ADDENDUM #2

Job #: 241829 **Project Title** The Commons at Highland Heights
Client: City of Highland Heights

Issue Date: November 18, 2025
Bid Date: November 25, 2025

Revised Plan Sheet (Page 21)

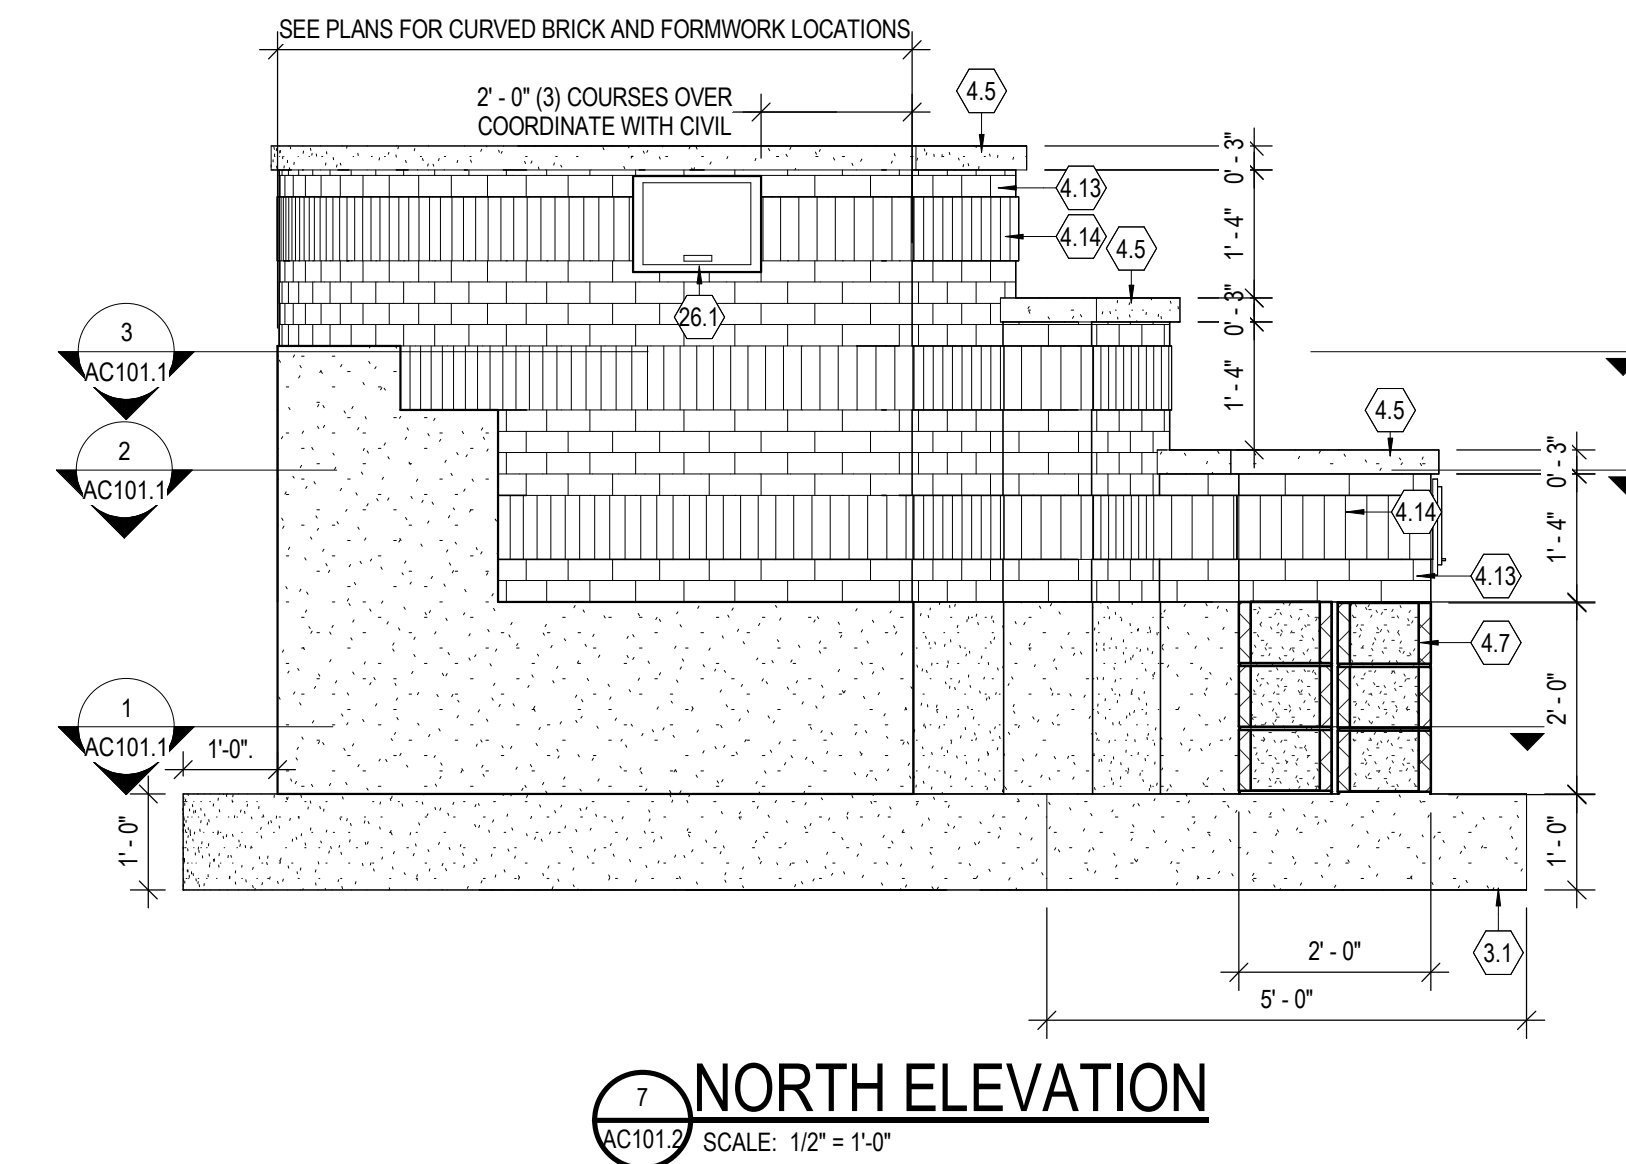
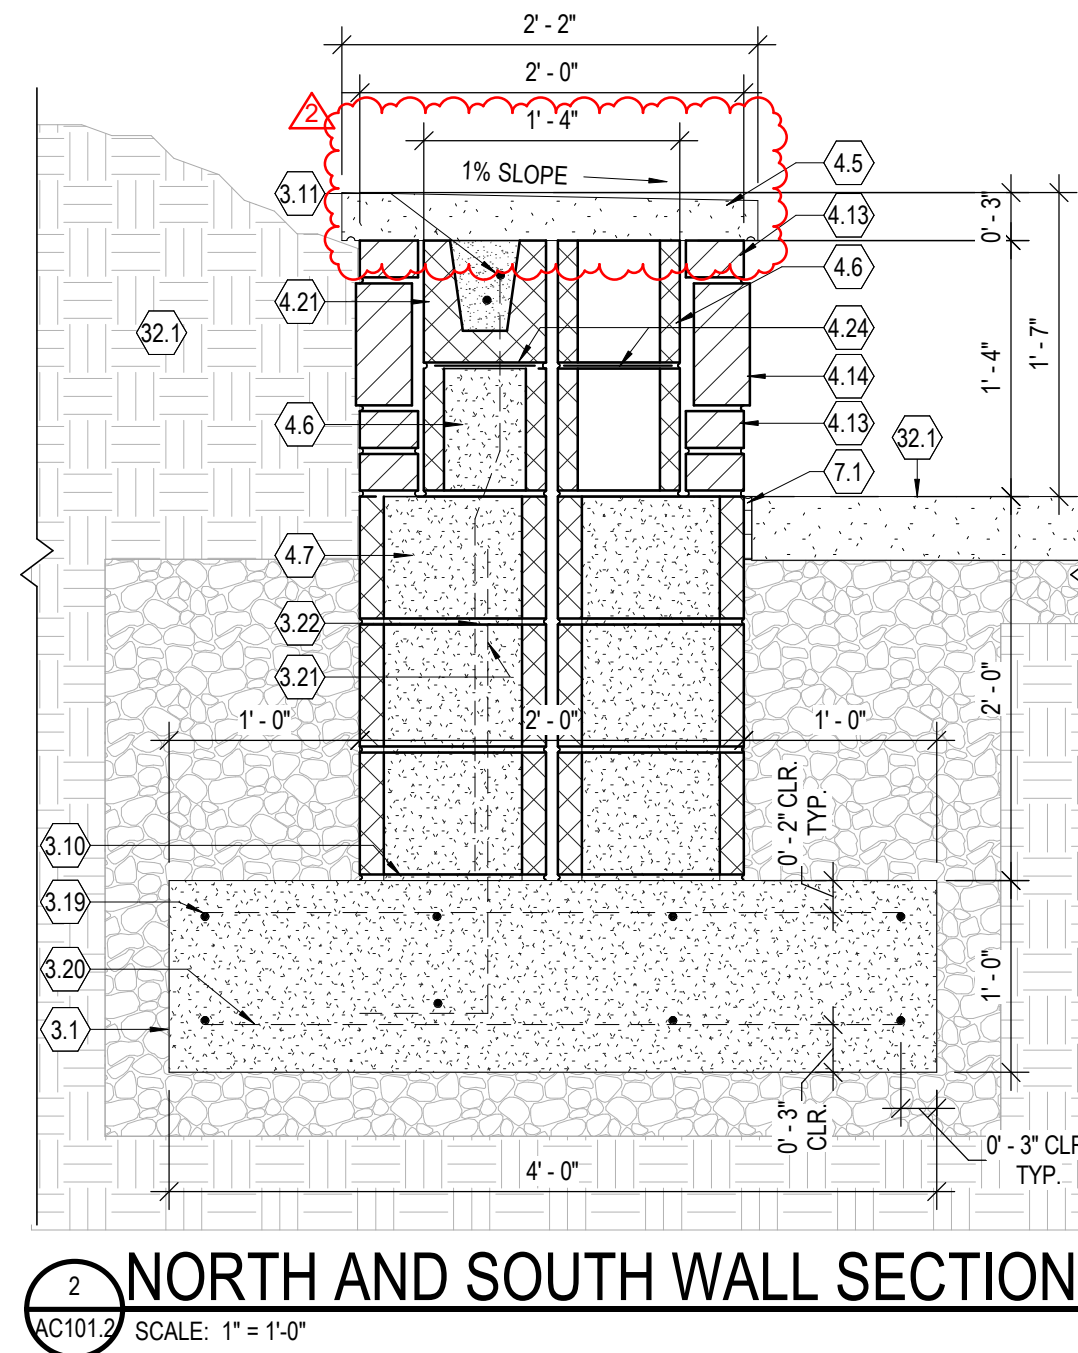
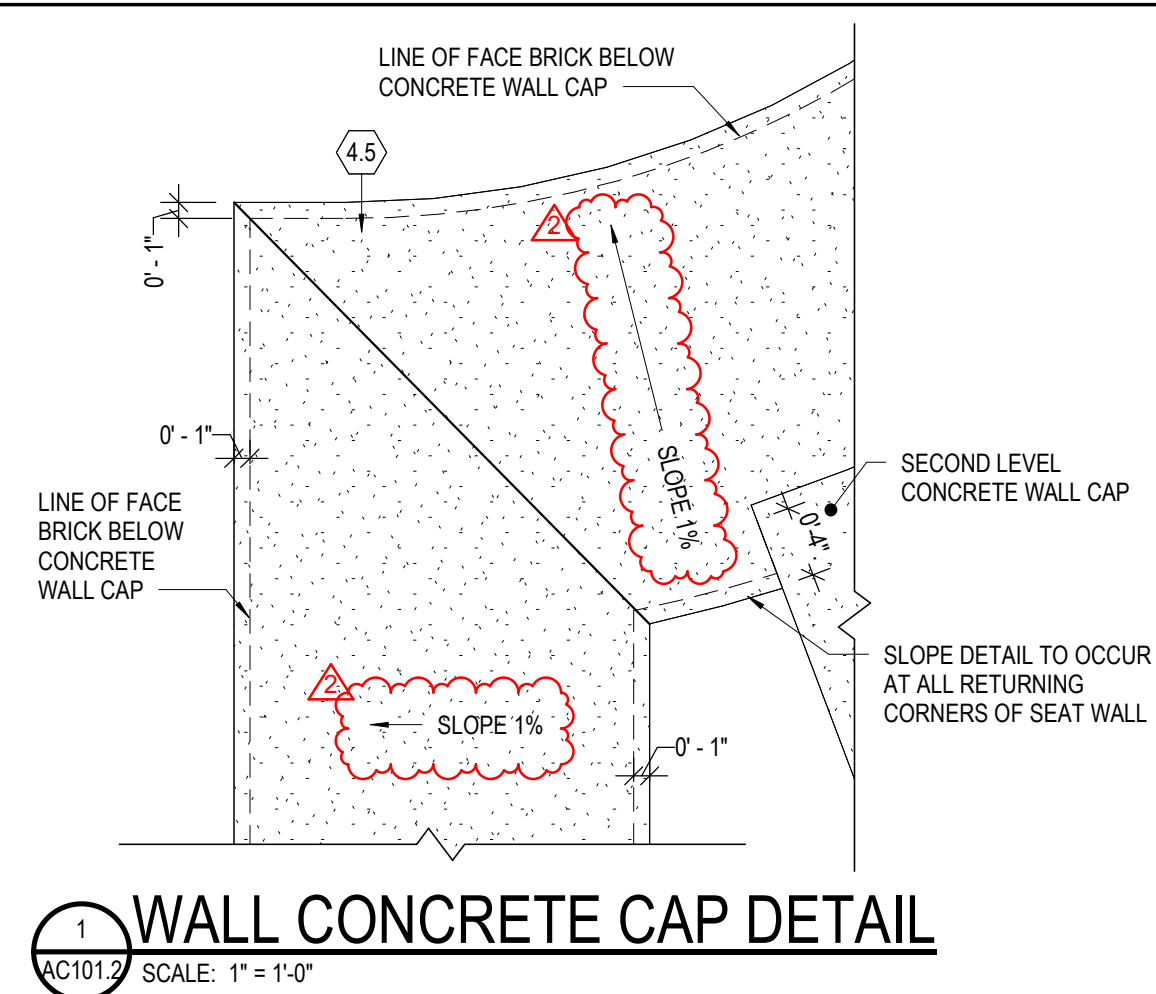
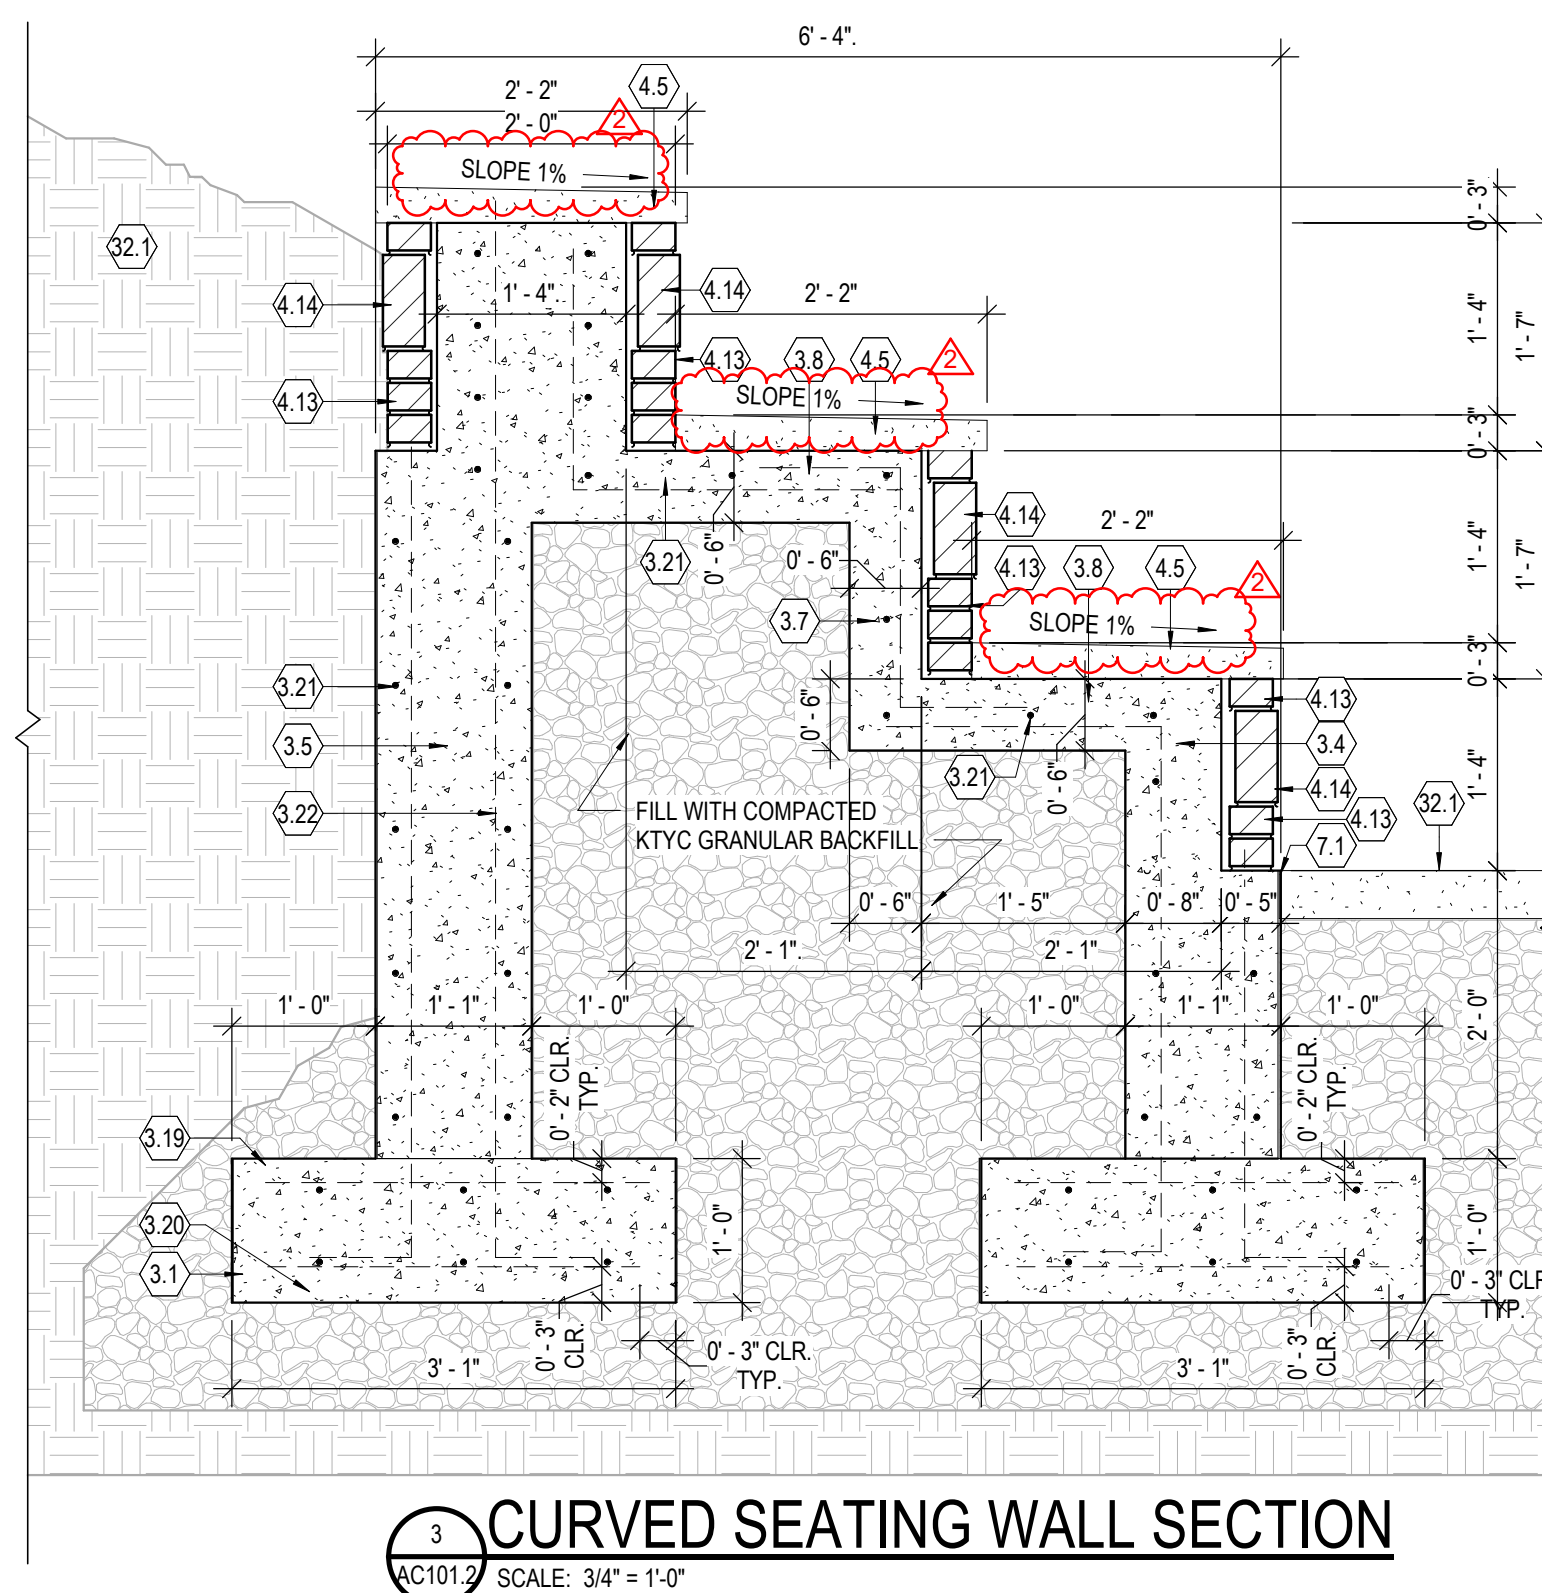
The curved seating wall cap slopes have been adjusted. Please see the revised plan sheet (attached).
